STAFF REPORT: APPEAL – REVISED FINDINGS

Appeal number..... A-3-MCO-04-012, Laube & Engel Residence

Project location.....36240 Hwy. 1 (Kasler Point), approx. 0.5 mile south of Garrapata Creek, Big Sur Coast, Monterey County (APNs 243-251-012 & 243-251-013)

Project descriptionConstruct a 8,270 sq. ft. single family residence with an approx. 1,824 sq.ft. subterranean garage, including development within 100 feet of environmentally sensitive habitat (ESHA), approx. 1,750 cubic yards of cut and 736 cubic yards of fill, slopes over 30 percent, and a lot line adjustment that will consolidate two adjacent two-acre parcels.

EXHIBIT NO. 5
APPLICATION NO. A-3-MC-04-012
Revised Plans
Dated 7/8/04
California Coastal Commission

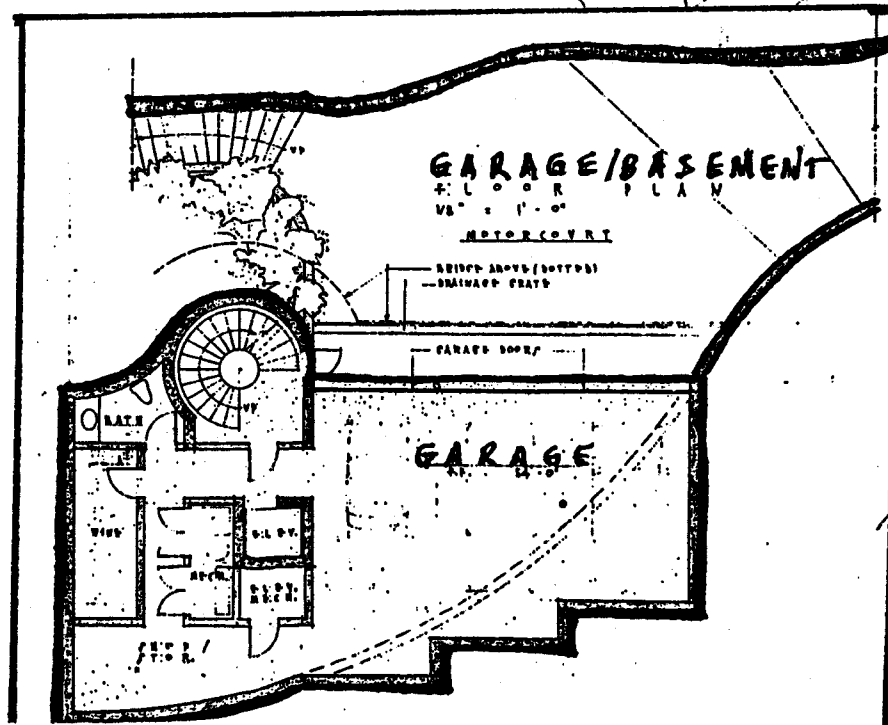
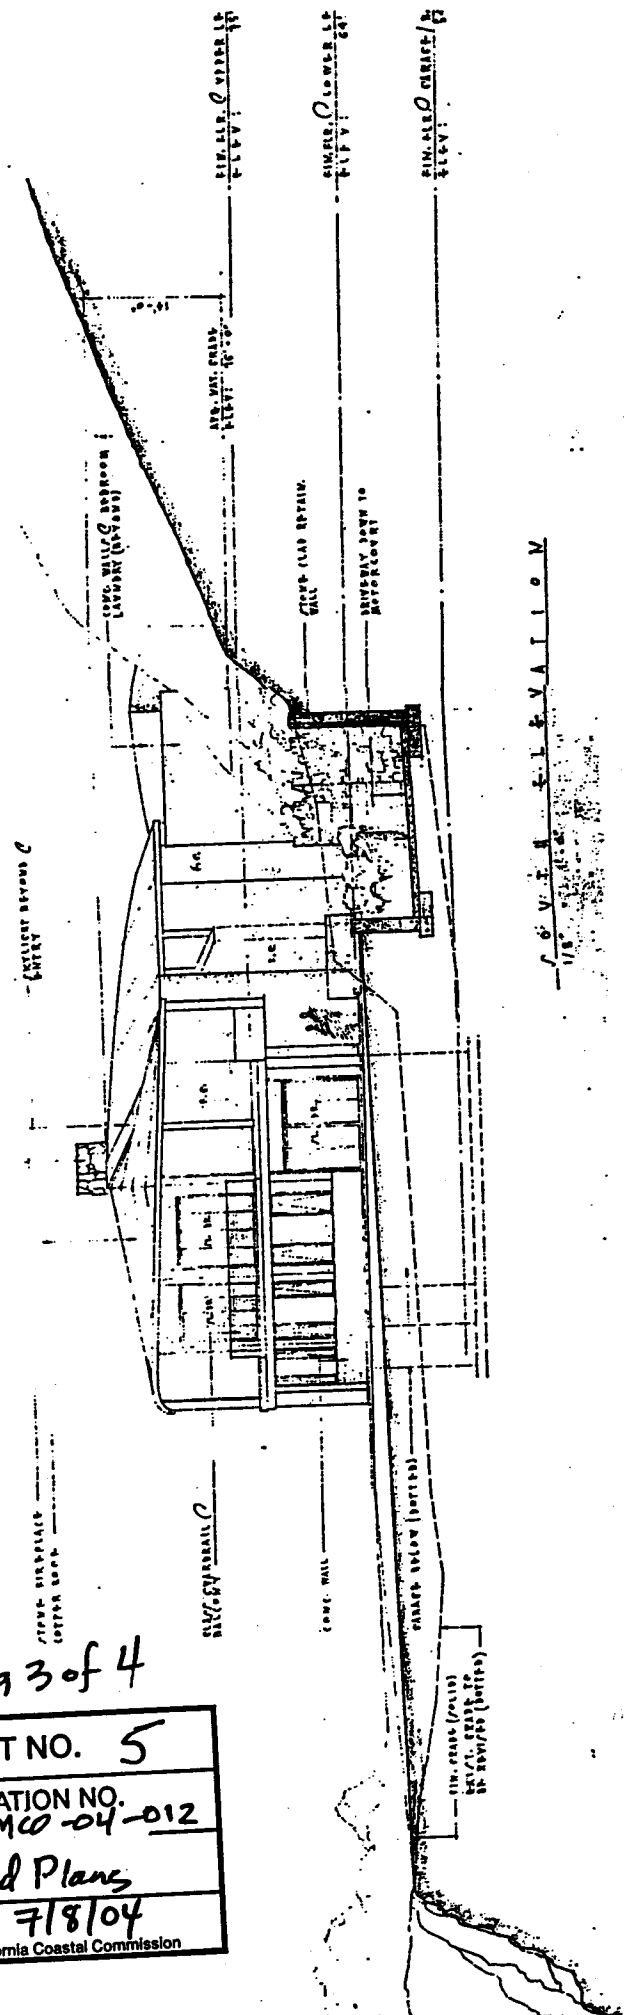
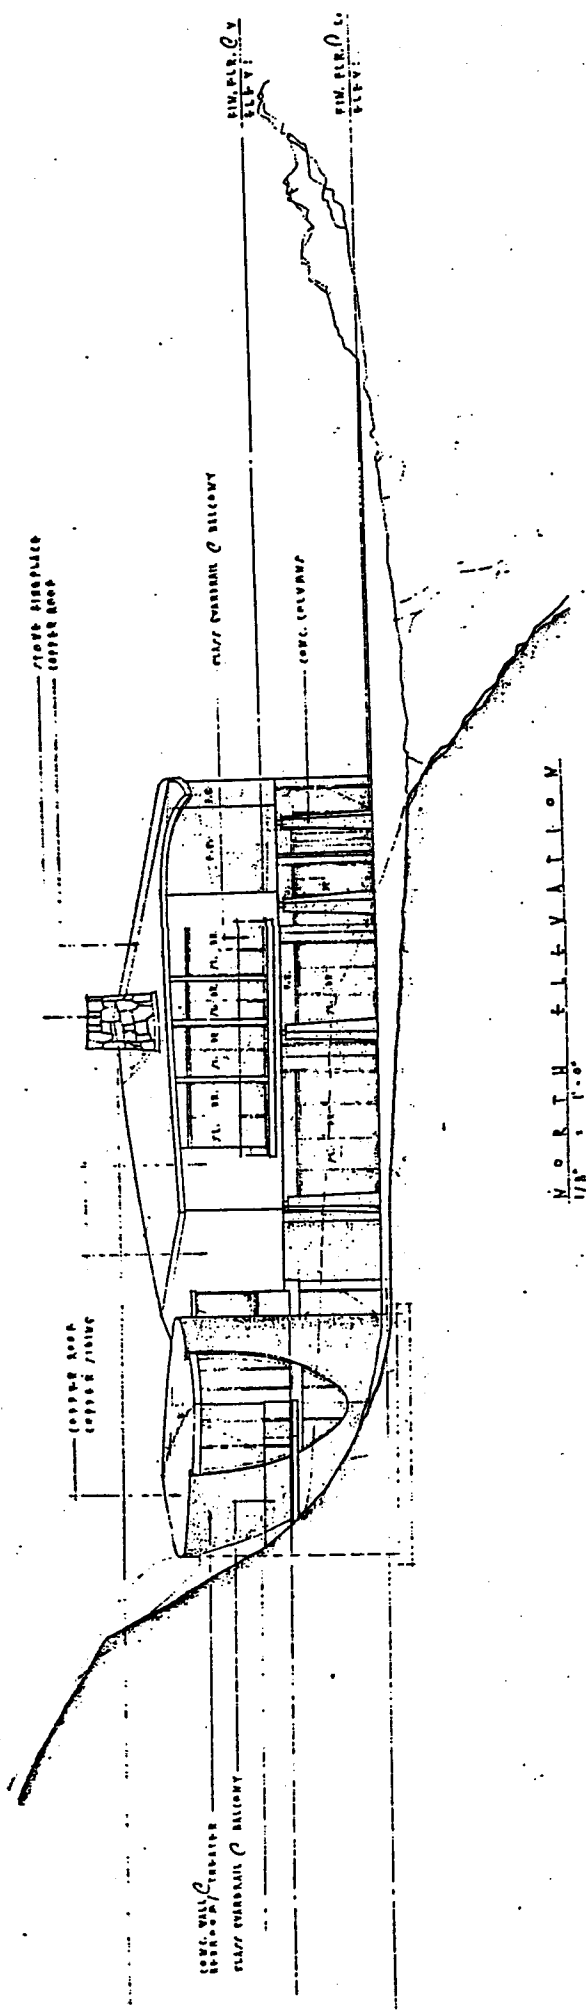
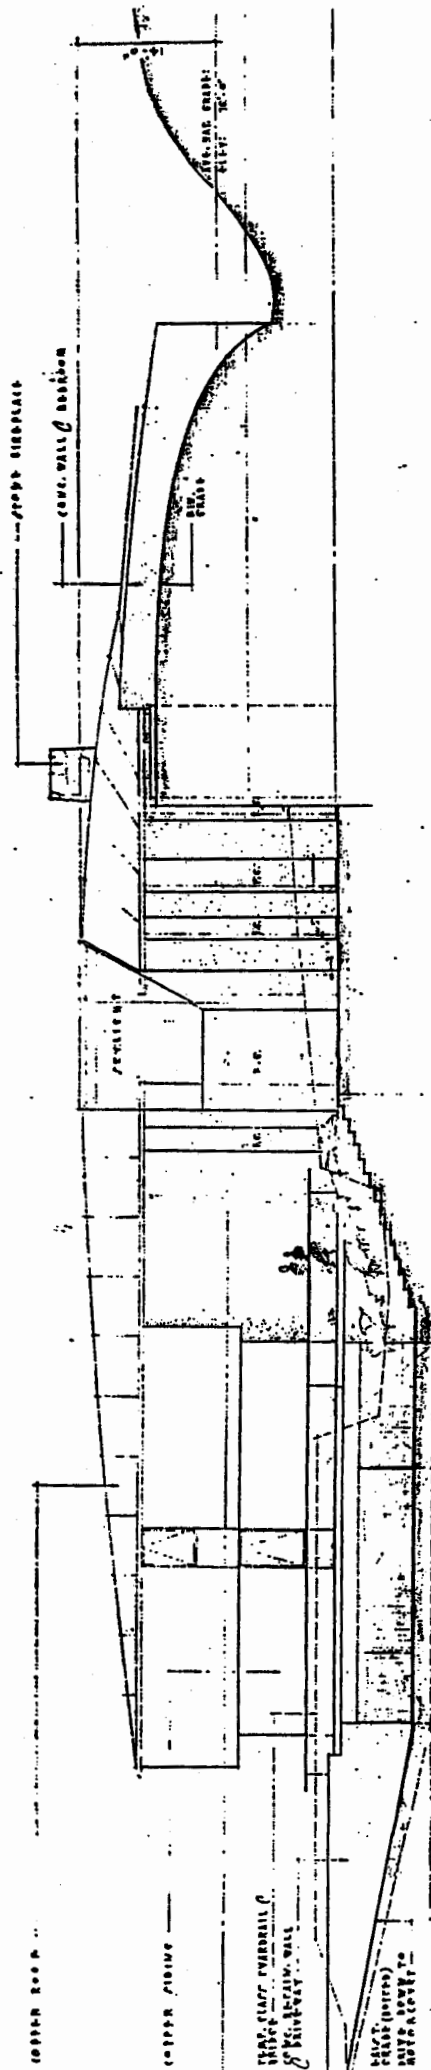
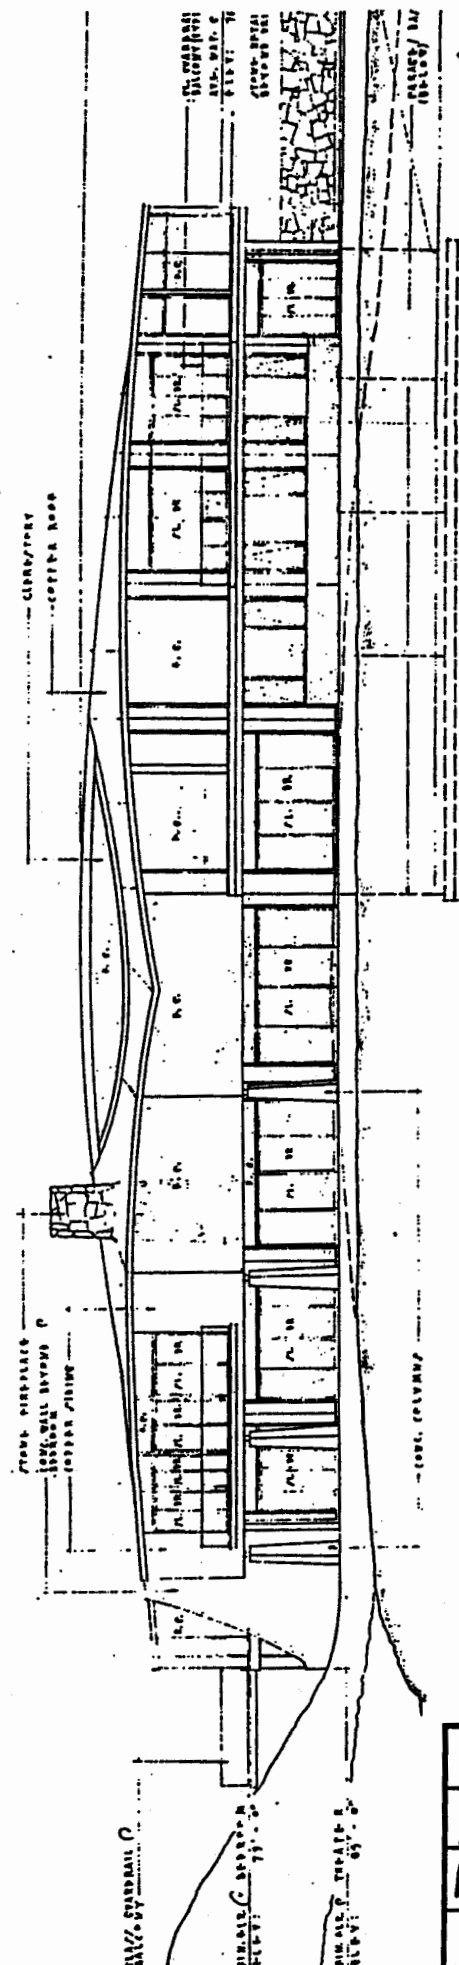
As described above, and shown on plans dated revised July 8, 2004 (Exhibit 5), following appeal of the project to the Commission, the applicants revised the design and location of the structures in an attempt to make the house less visible. Specific changes include moving the structure further northward so that the home theater portion of the residence is now located on the northern parcel, and lowering the base and roof elevation of the northern portion of the house so that it would not be seen from Highway One. According to the applicant's representative, the square footage of the house was also reduced approximately 123 sf (from 10,094 sf to 9,971 sf). After staking of the new design, Commission staff met with the architect and applicant's representative at the site to conduct a visual analysis of the new design (as represented by staking and flagging of outer walls and roofline). As a result of the site visit, staff determined that while the revised design is not visible from Highway One directly east of the site, due to existing topography, a portion of the house is would still be visible from Highway 1, both north

The parcel is zoned RDR/40(14) meaning that the height limit is restricted to 14 feet above average natural grade. The revised July 8, 2004 plans submitted by the applicants (Exhibit 5) show an approximate average natural grade at an elevation of about 76 feet. Sheet 1 of the plans show that this was calculated given a high point at natural grade of 87 feet, where the northern portion of the house would be set back into the excavated bluff, and a low point at natural grade of 65 feet, at the outboard edge of the first floor. If one were to imagine the natural average grade being a straight line between these points, the average elevation of that line would be at 76 feet, as calculated.

As currently designed (based on the revised July 8, 2004 plans), the project's size, height, location, and ~~visually prominent location (rotated out from the excavated bluff face)~~ **roof color minimize impacts on still prevent conformance with the LCP's visual resource protection policies for views seen from Highway 1.** While large homes are often the preference of coastal property owners these days, policies of the Big Sur LUP require that the siting, size and design of homes be modified where necessary to **cause the homes to be subordinate to and blend with their environment. Measures must be taken to minimize visibility in the critical viewshed.** Zoning for the site also restricts the maximum height of main structures to be no more than 14 feet above average natural grade. While main structures in areas zoned RDR are allowed a maximum height of 30 feet, most of the residential parcels located between Garrapata Creek and Rocky Point were intentionally constrained with a maximum 14-foot height limit, specifically to protect visual resources along the coast.

1. The building plan (dated 11/16/04) has been further modified, ~~so that no portion of the structure will be visible from public viewing areas, and in no case is greater than~~ to indicate that no portion of the structure shall exceed 14 feet above average natural grade.

Southern elevation of proposed project design showing approximate portion of house visible from Rocky Point turnout

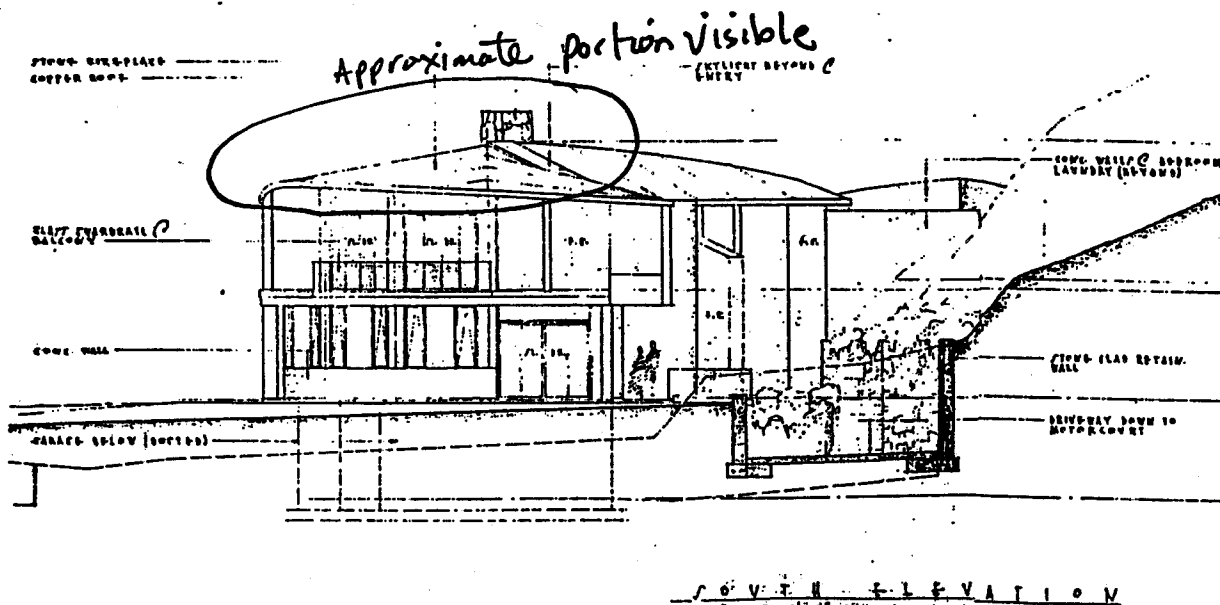
Evidence on the question of whether the structure is visible to the naked eye is conflicting. On the one hand, staff analysis based on field observations of project flagging from public viewpoints both north and south of the project site indicates that the structure would be visible. On the other hand, testimony and photographic documentation presented by the applicant, as well as an inspection of the site from public viewpoints by a Commissioner (Potter) supports a conclusion that the project will be invisible to the naked eye from such viewpoints. It is unnecessary for the Commission to definitively resolve this conflict in the record. This is because, considering all the evidence, the visual impacts of the proposed siting and design are minimized. If some small portion of the project will be visible from one or more public viewpoints, the topography of the site almost entirely screens the proposed structure from public views and the structure would be located on the portion of the site that is least visible to the public. Although the roof will

Exhibit 9- pg | of |
Scenic & Conservation Easement
Required by Special Condition #4

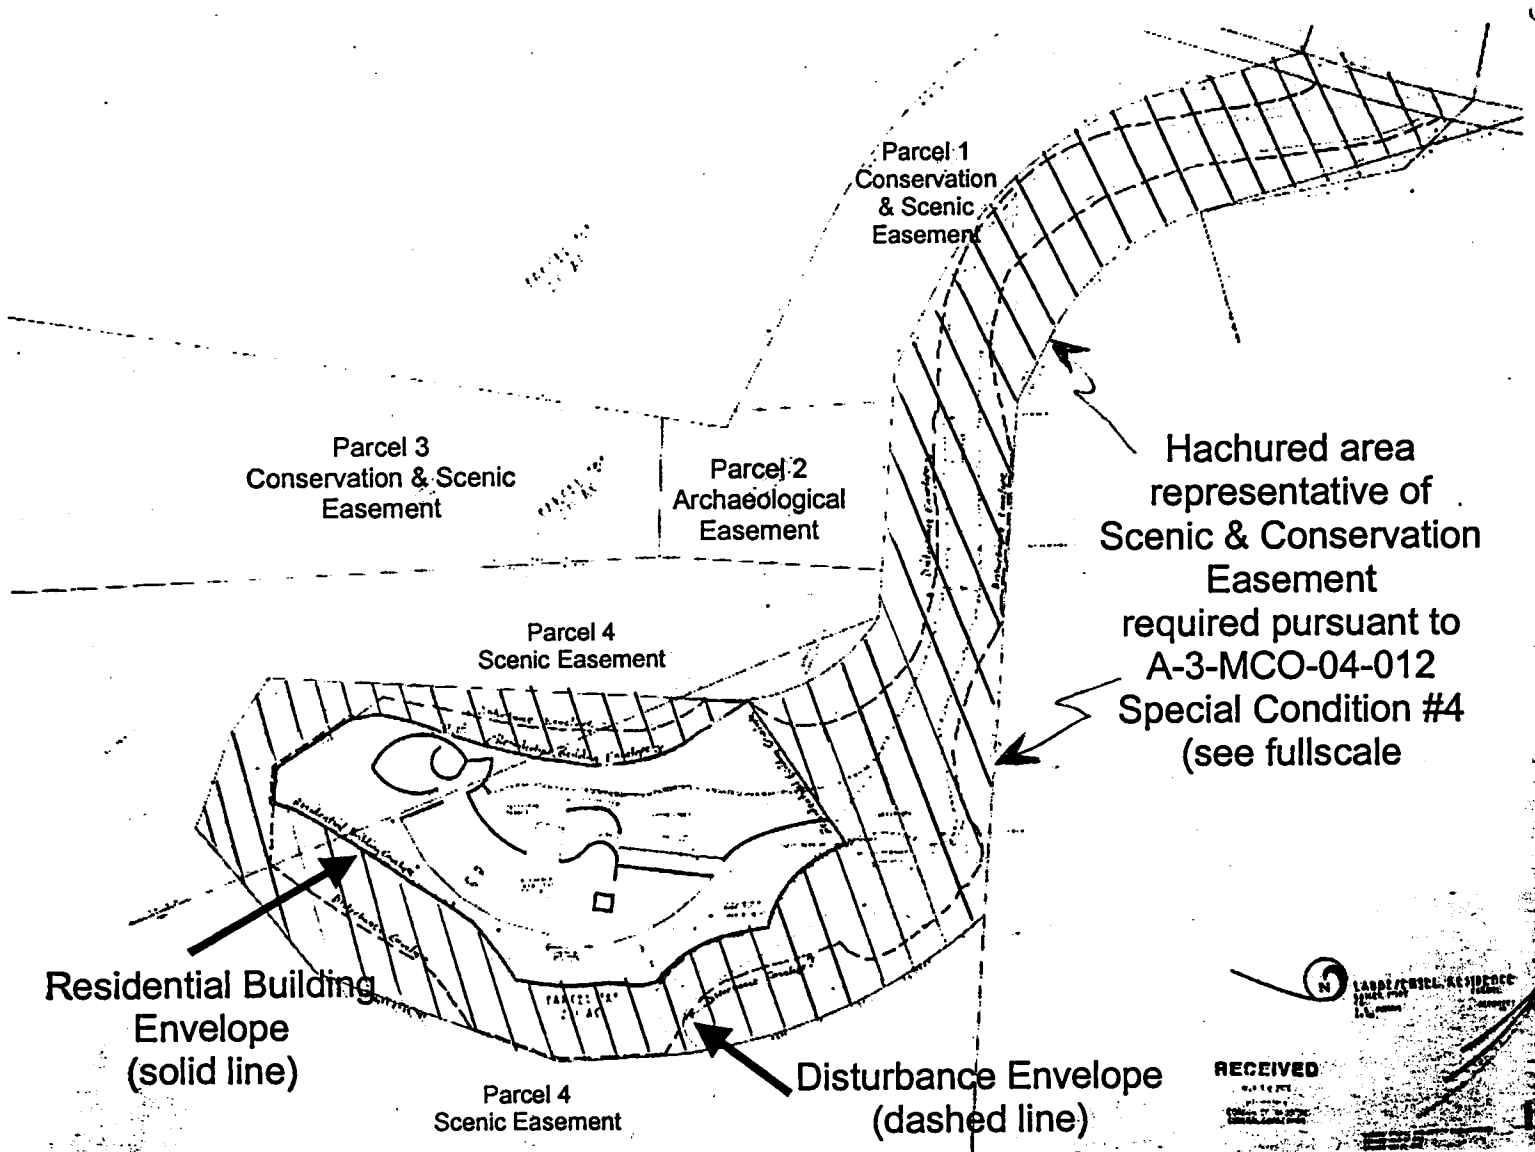
4. **Scenic and Conservation Easement.**
- a. No development, as defined in Section 30106 of the Coastal Act, shall occur in the area on both parcels (to be merged) outside of the final approved Residential Building Envelope, other than the access road/driveway, guest parking and turn-around areas, retaining walls, and drainage improvements, all as shown on the approved plans required in Special Condition 1a and 1b; grading and erosion control activities in conformance with the grading and erosion control plans required by Special Condition 1c; landscaping and restoration activities in conformance with the approved landscape and revegetation plans required by Special Condition 1d; and ongoing maintenance and repair of such development.

- b. PRIOR TO ISSUANCE OF THE COASTAL DEVELOPMENT PERMIT, the applicant shall execute and record a scenic and conservation easement in a form and content acceptable to the Executive Director and the Director of the Monterey County Planning and Building Inspection Department, for the purposes of visual resource protection and habitat conservation. Such easement shall be located on that portion of the combined parcel (created by combining the two subject parcels, Assessor Parcel Numbers 243-251-012-000 and 243-251-013-000, as required in
